Objection to proposed roof terrace at 1 Gladys Road with Changes. (2021/0971/P) Updated 19th May

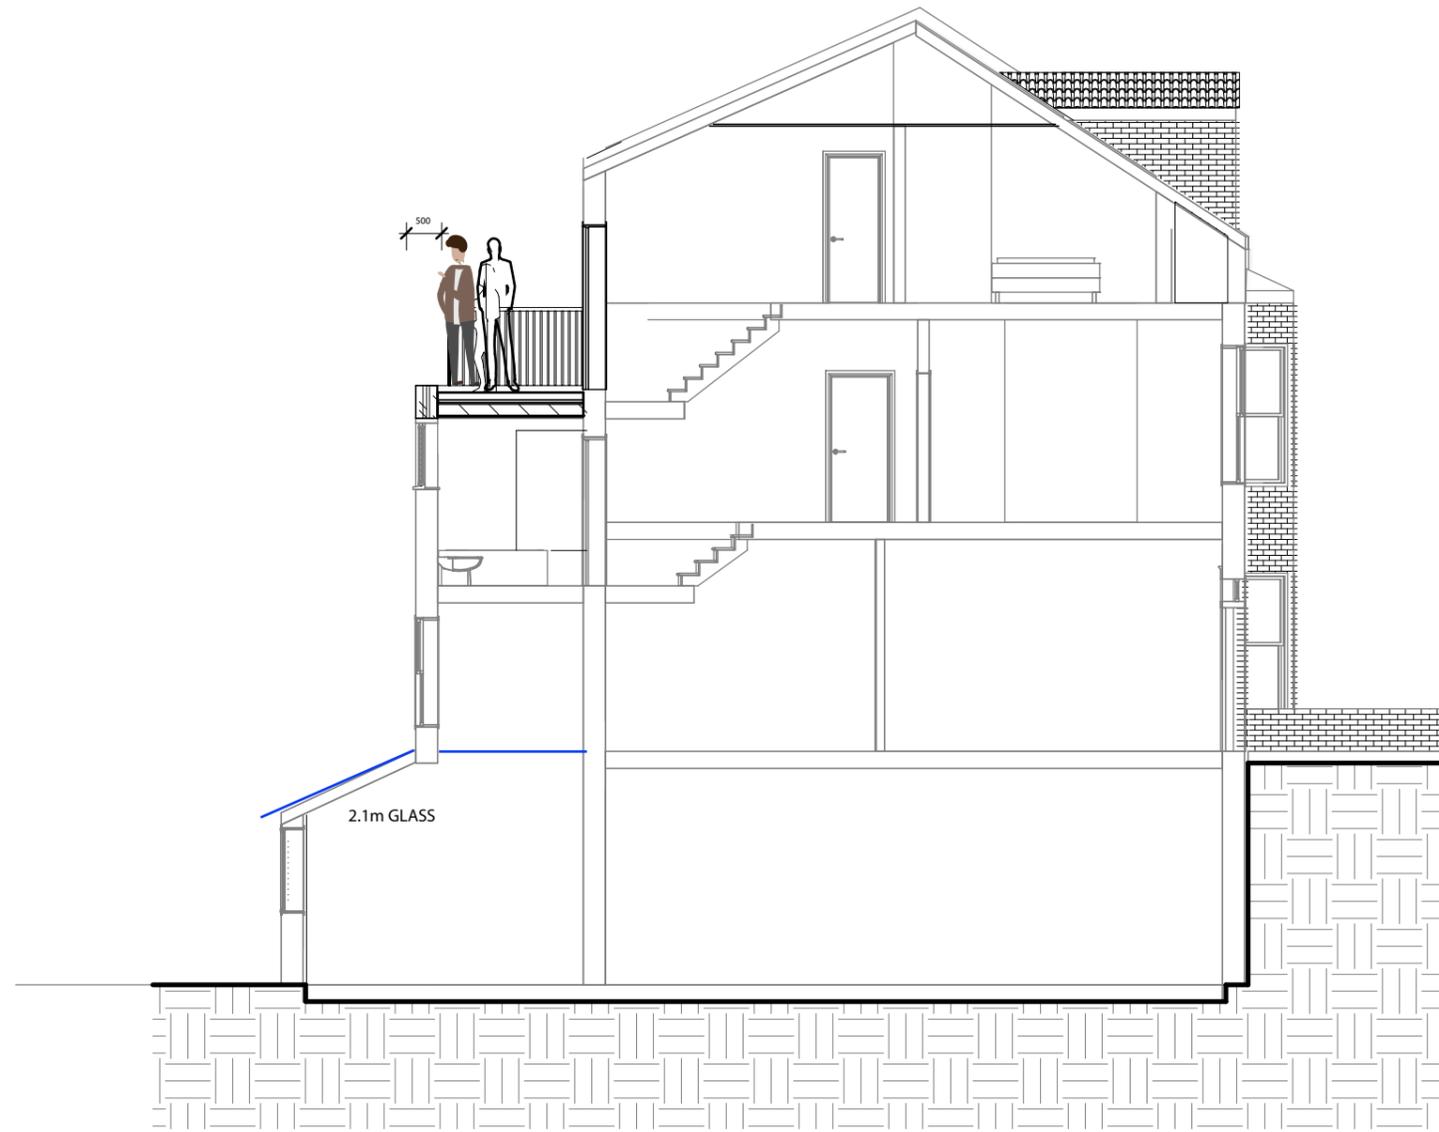
1.1. Due to the angle of the sloping glass roof, the proposed terrace would still be able to see into our living area even with the indent railing. .

The Indent 500 of 2715mm you would still see into our glass roof.

There is no measurements on the heights of the railings on the drawings

The average height of railing is (900mm- 1 meter) (Door 2 meters).

Height average Male: 1.8 m / Female: 1.6 mn

The railing of 500 of the 2715 you could see into the glass roof.

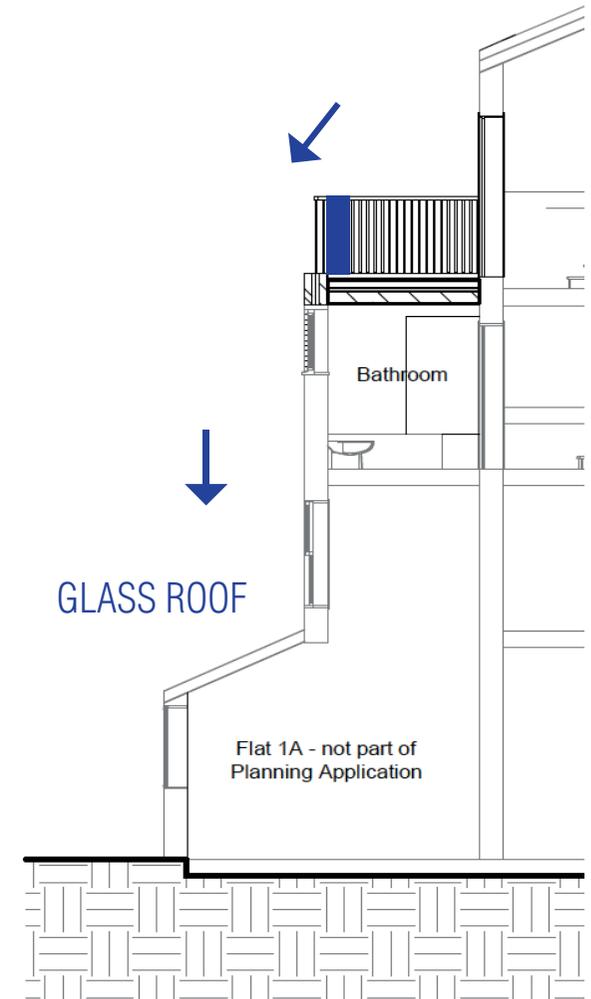
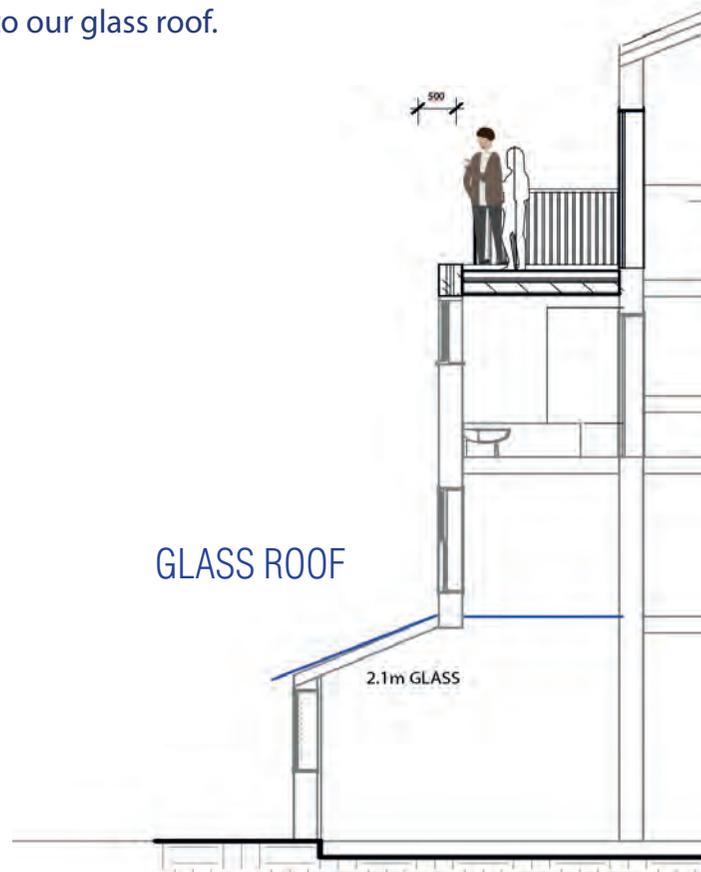
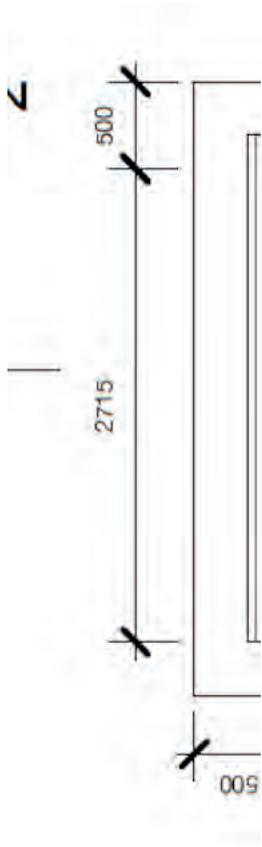
1.1. Due to the angle of the sloping glass roof, the proposed terrace would still be able to see into our living area with with the indent railing

There is no measurements on the heights of the railings on the drawings

The average height of railing is (900mm- 1 meter) (Door 2 meters).

Height average Male: 1.8 m / Female: 1.6 mn (person on drawing small).

The Indent 500 of 2715mm
you would still see
into our glass roof.

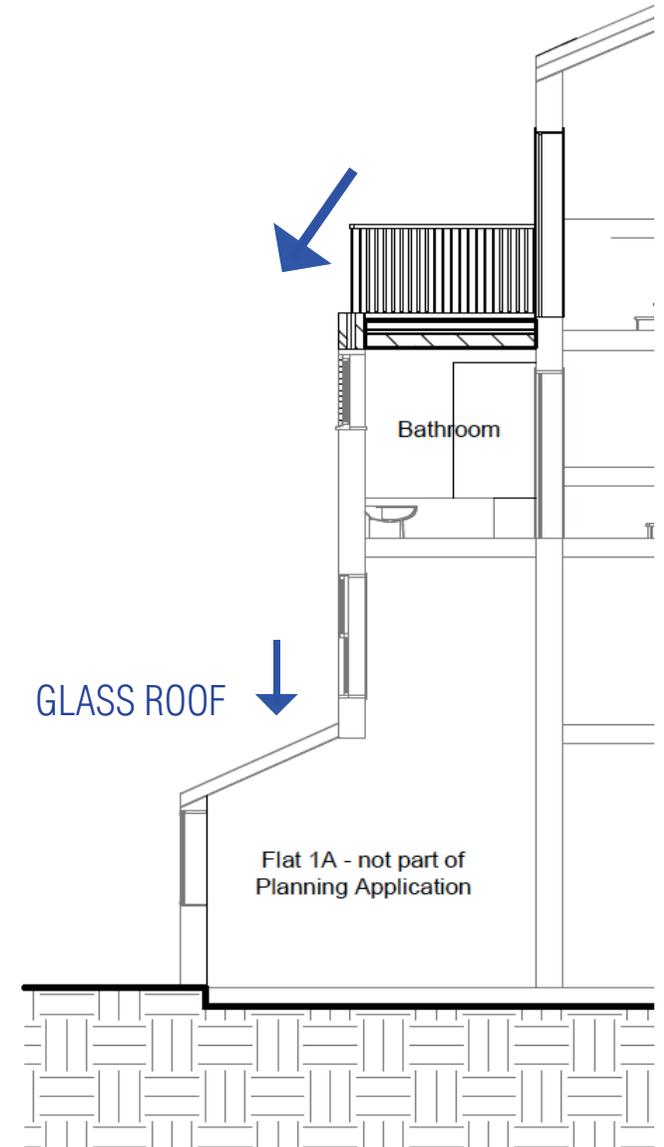
5. It would look directly in our garden giving our loss of privacy. (ref 5)

5.1 The updated drawings of the terrace would look directly in our garden giving loss of privacy of the 3 bedroom flat downstairs.

E East
1 : 200

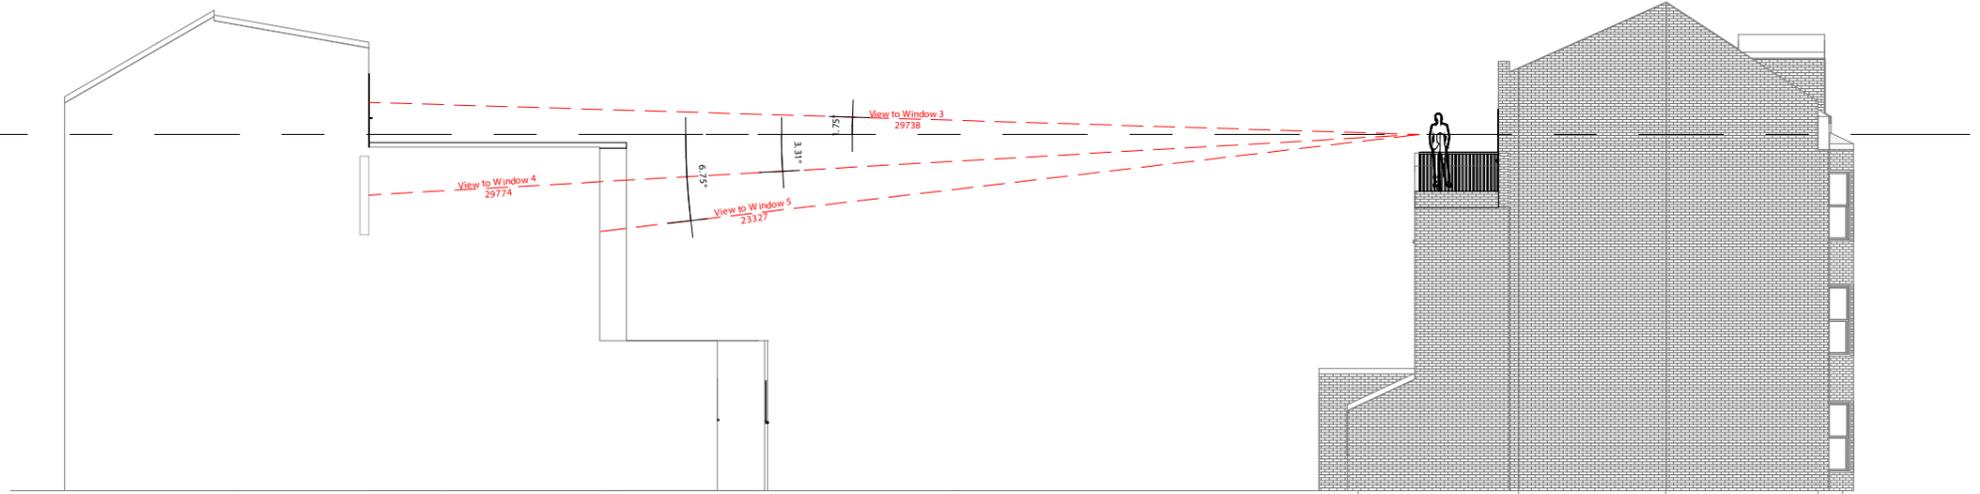
Based on average height of person.
 View into: window 2a, 2b, 1 - after set back 50cm change
 View into: window 11-23, after changes set back on drawing (based on eye height)
 View into: windows 3-5, after changes set back on drawing

Av. View Height on
Proposed Terrace
6777

Av. View Height on
Proposed Terrace
6777

Av. View Height on
Proposed Terrace
6777

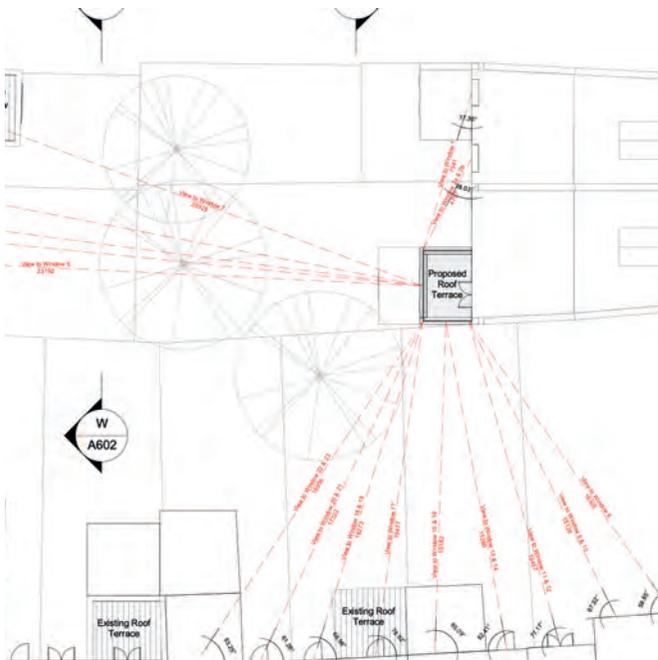
9.1- You will still be able to see out to all 13 flats.

There is no measurements of the railing, or side parapet wall height on drawings. Based on scale of person, door height and persons eye height you would still have a clear view to all properties.(windows 8-23)

Facing forward the terrace will have direct view into Hemstall Road properties. (windows 3,4,5,6)

Right side: The terrace will have view into windows (1,1a 2b) from terrace angles.

The terrace will have view into 3 Gladys Road skylight
